**RC10
B6.4
TEAM KIT**

RC10B6.3 vs. RC10B6.4 Comparison

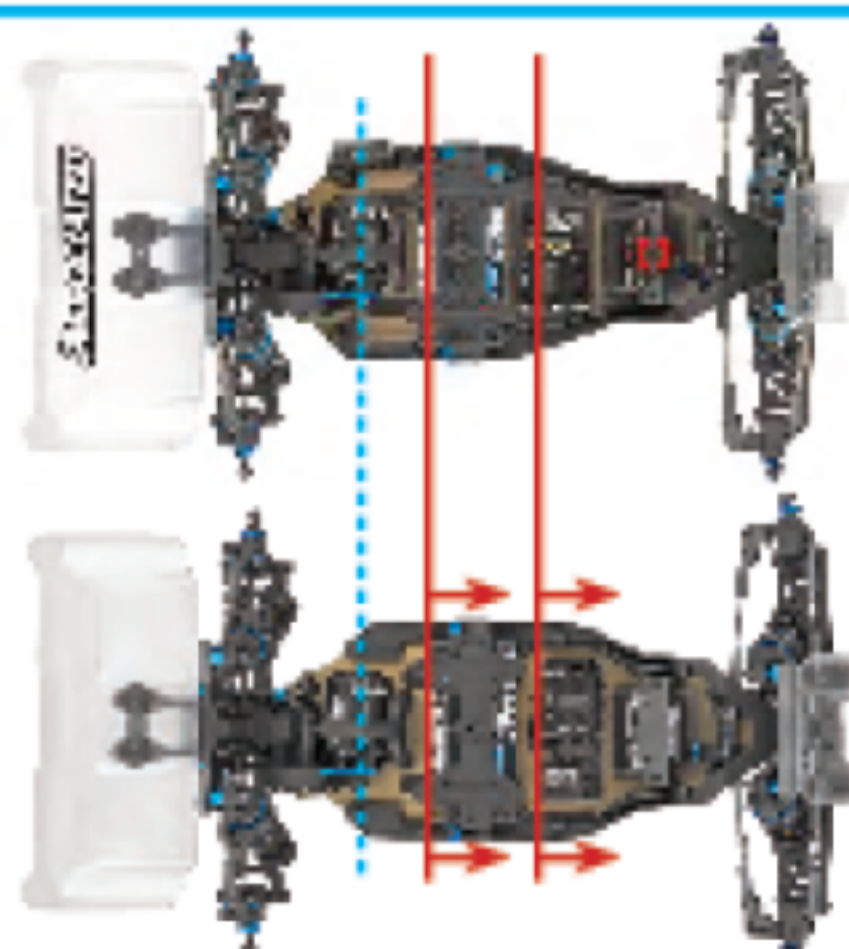
Updated top plate and ballstud mount

**RC10
B6.4
TEAM KIT**

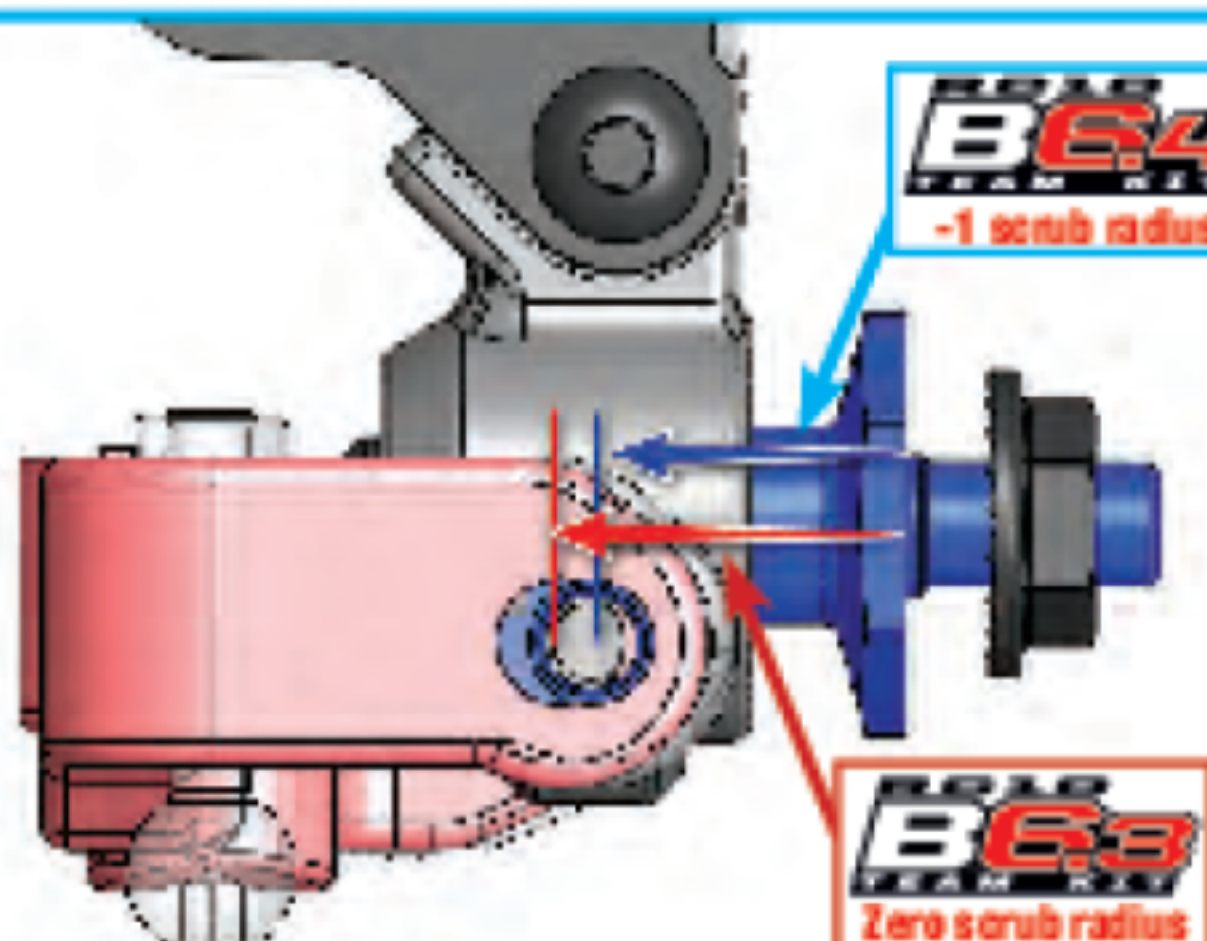
New chassis profile and ESC tray location. B6.4 has weight moved forward.

New adjustable height steering system.
B6.3 is not adjustable
